Addressing Clause 184 D1.2 text for 800GBASE-LR1

(Support contribution for Comments #420, 422, 423,
424, 425, 426)

P802.3dj Plenary Meeting, Vancouver, Canada, Nov 2024

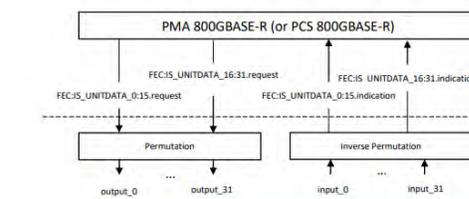
Comment #420: Naming of RX signals

- Comment:
 - ADC input signals in Figure 184-2 are labelled RX_Ai, RX_Aq, RX_Bi and RX_Bq. I think the labels A/B are used to highlight the fact that the polarization angle at the receiver is not necessarily aligned with the X/Y polarizations at the transmitter. However, A/B are somewhat arbitrary and do not clearly reflect the fact that those are orthogonal polarizations.
- Suggested Remedy:
 - Use H/V (for horizontal and vertical) instead of A/B because it is common to use these letters in coherent DSPs instead of X/Y to indicate orthogonal polarizations. i.e. use RX_Hi, RX_Hq, RX_Vi, RX_Vq. Same change would also apply to uses of these names in 184.5.1 on page 508, lines 45, 47 and 51 and in 184.5.2 on page 509, line 5 and 184.5.7 on page 510, line 10.
